Statement of Response to ABP's Opinion

**Proposed Strategic Housing Development
(Alterations to Phase 1 Residential and
Proposed Phase 2 Residential Development)**

**Frascati Centre, Frascati Road, Blackrock, Co. Dublin
(formerly known as Frascati Shopping Centre).**

John Spain Associates

Figure 1: Changes to Proposed Phase 2 Residential Development (View from the North West Corner)

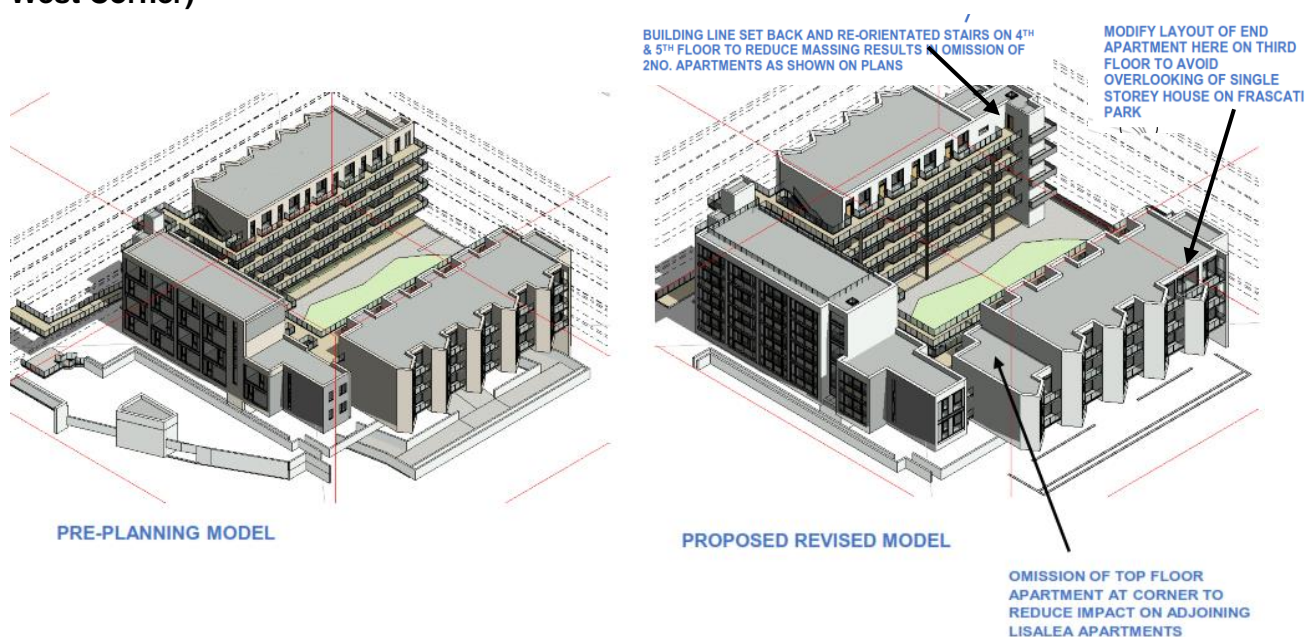
1) *Rationale for the proposed height of the development which should include consideration of all phases within the development. The rationale should be informed by both design consideration and potential impact upon adjoining residents' amenity. A resulting explanation should be provided for the suitability of parts of the site for the inclusion of taller elements. The application should be accompanied by a material contravention statement where heights exceed local planning policies for the area.*

- 2.5 Following detailed design consideration, and having regard to the issues raised at the tri-partite meeting and in the Board's Opinion in respect to building height and impact

on neighbouring properties, the following changes are incorporated into the proposed Phase 2 residential development when compared to the pre-application scheme:

- Omission of 1 no. apartment unit at third floor level of Block F to reduce the corner height on the north western corner from 3 to 2 storeys and reducing impact on adjoining Lisalea. The overall height of the north western corner is reduced from 18.9m to 15.3m;
- Modified layout of Apartment No. 2315 at third floor level of Block F to avoid overlooking onto Frascati Park;
- Building line setback at the south eastern corner and reoriented stairs on 4th and 5th floor of Block D to reduce massing resulting in omission of 2 no. apartments. The separation distance to No. 37 Frascati Park has increased from 30.7m to 33.5m.
- The changes result in total number of units being reduced from 105 no. units to 102 no. units.

2.6 Figures 1 and 2 illustrates the proposed changes to the scheme and we refer the Board to Reddy A+U Architectural Response document which clearly demonstrate the changes to the development and the suitability of the subject site to accommodate the proposed scale and heights in the context of the surrounding development and the high-quality architecture proposed. The revisions are considered to ameliorate any impact of overlooking and adverse visual impact on neighbouring properties. It is respectfully submitted that the proposed revisions adequately address any concerns in respect to proposed building heights and impact on neighbouring properties.

Figure 5: Proposed Private Amenity Area for Studios fronting toward Dublin Bay

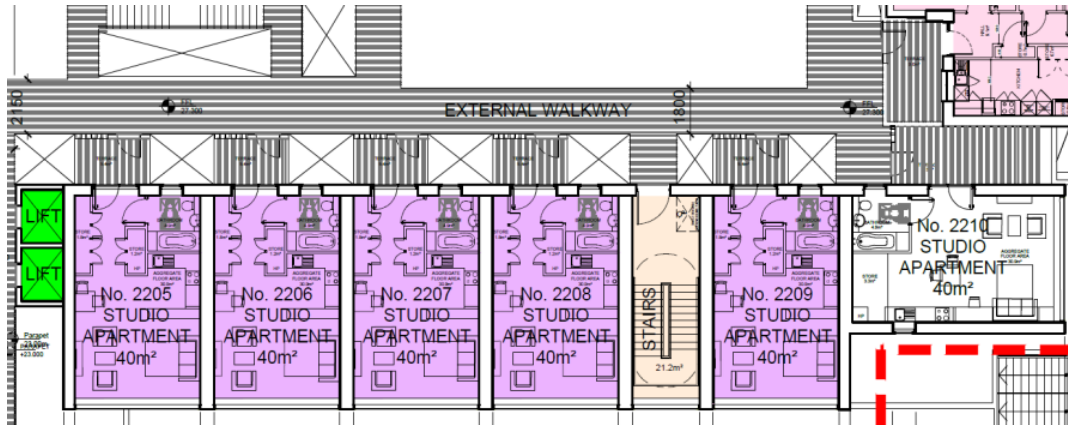
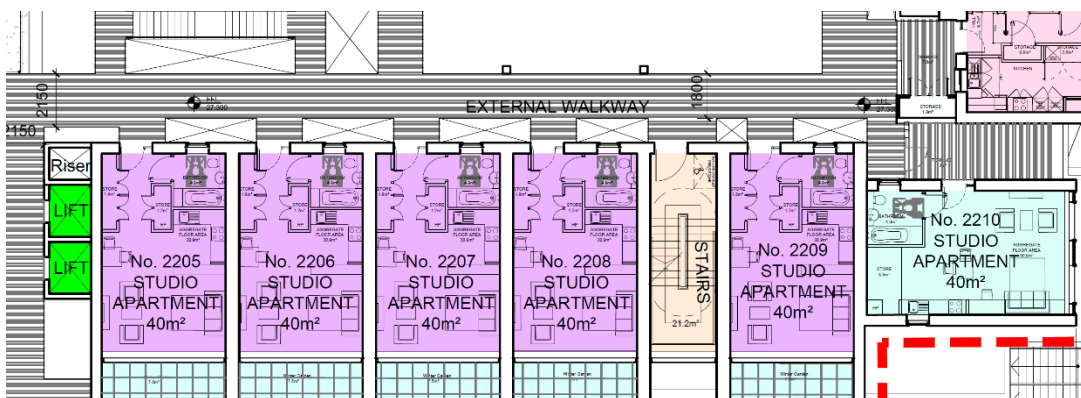
8) *Rationale for the location of private amenity spaces to studio apartments and the type of treatment/planting to be included that will be suitable for the location/aspect.*

- 2.35 We refer to the Architectural Statement of Response Brochure prepared by Reddy A+U which illustrates the revised studio unit arrangement and associated private amenity spaces. In summary, following detailed design review, it is proposed to relocate the private amenity spaces for the studio apartments to winter garden type balconies to the north east elevation with views towards Dublin Bay, as illustrated below (in contrast to the pre-application proposals).

- **Private amenity space provision for the proposed Studios within the 'Phase 2' scheme.**
- 3.15 As set out above, we refer to the Architectural Response Brochure prepared by Reddy A+U which illustrates the revised studio unit and associated private amenity spaces. In summary, following detailed design review, it is proposed to relocate the private amenity spaces for the studio apartments to winter garden type balconies to the north east elevation with views towards Dublin Bay, as illustrated below.

- 3.16 The revised private amenity spaces are considered to be more appropriate and address the concerns raised by the Planning Authority.
- **Further details of the proposed winter gardens should support the full application for planning permission.**
